ATTACHMENT 2

TECHNICAL SPECIFICATION PAGES WITH PEN AND INK CHANGES

LICENSE APPLICATION 91-08, NLR-N91131  
SPECIMEN REMOVAL SCHEDULE RELOCATION

FIGURE B 3/4 4.6-1 FAST NEUTRON FLUENCE (E>1 Mev)  
AT 1/4 T AS A FUNCTION OF SERVICE LIFE\*

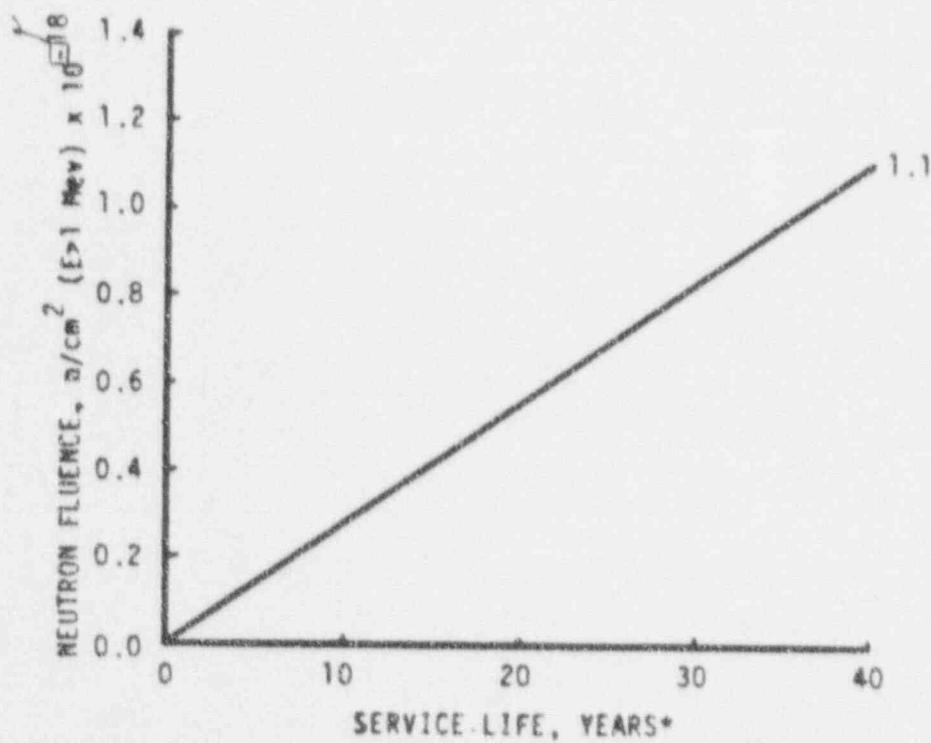
<u>Technical Specification</u>	<u>Page</u>
4.4.6.1.3	3/4 4-22
Table 4.4.6.1.3-1	3/4 4-24
Bases 3/4.4.6	B 3/4 4-6
Figure B 3/4.4.6-1	B 3/4 4-8
